Cellular E-field – Max 188.8 V/m (M3)

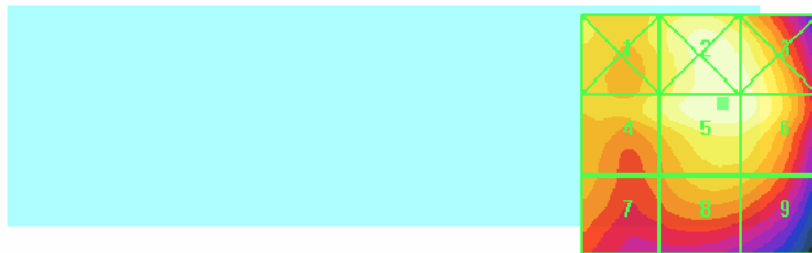
Please update your data to show both the original RF scan field strengths and the offset field strengths for the blocks where there is any increase in maximum field strength within the block. Please provide the new maximum field strengths in the worst case block. Please do for Worst case E, and H fields for both bands.

Please find below data for worst case E and H fields for both bands. These clearly show that the M3 rating is maintained at the T-coil center.

Grid 1	Grid 2	Grid 3
163.6	185.7	184.7
Grid 4	Grid 5	Grid 6
167.9	188.8	186.8
Grid 7	Grid 8	Grid 9
144.9	156.3	154.0
